petco
 PETCO ANIMAL SUPPLIES STORES, INC. 6834 WESLEY STREET GREENVILLE, TX

DISTRIBUTION:	DATE:
25% SUBMISSION	06-28-11
75% SUBMISSION	08-11-11
98% SUBMISSION	08-16-11
100% SUBMISSION	09-23-11
PERMIT SET	09-28-11
FINAL PERMIT SET	09-20-13
BULLETIN 1	10-22-14

DRAWING TITLE:
 STORE FIXTURE PLAN
A2.3

STORE FIXTURE PLAN	01
REF.:	SOURCE: 1/8" = 1'-0"

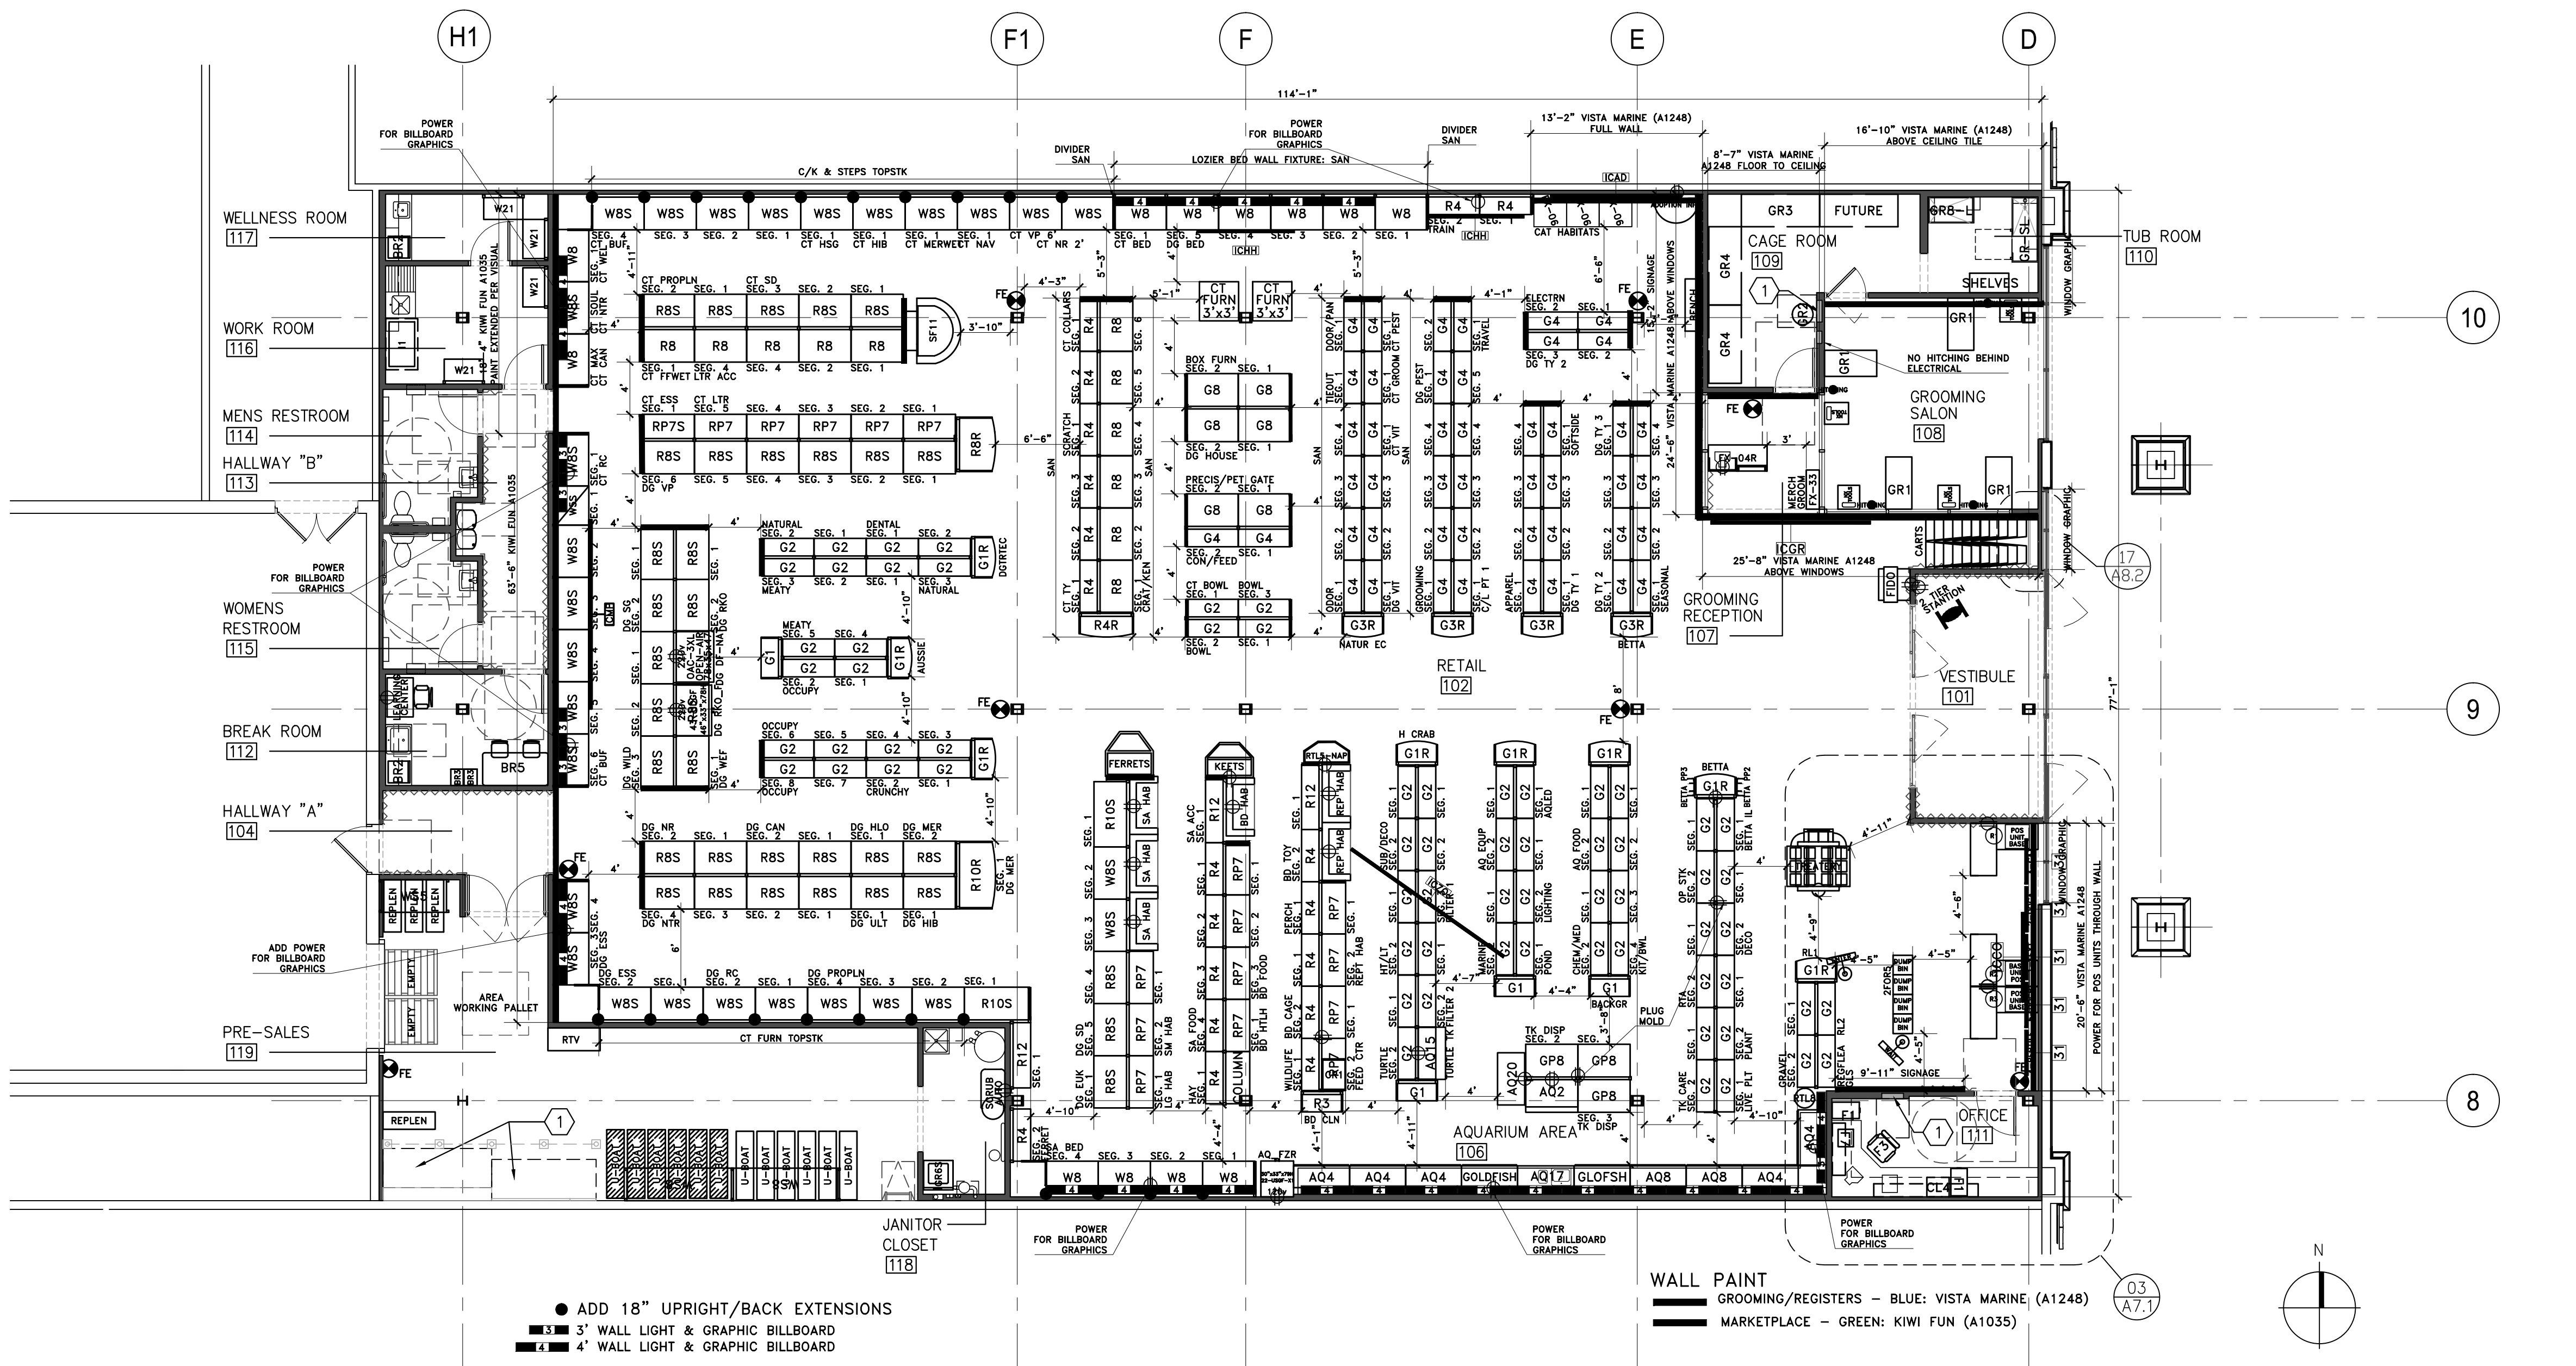
REVISED FIXTURE PLAN AND KEYED NOTES, ACCESSIBLE COUNTER DETAIL ADDED
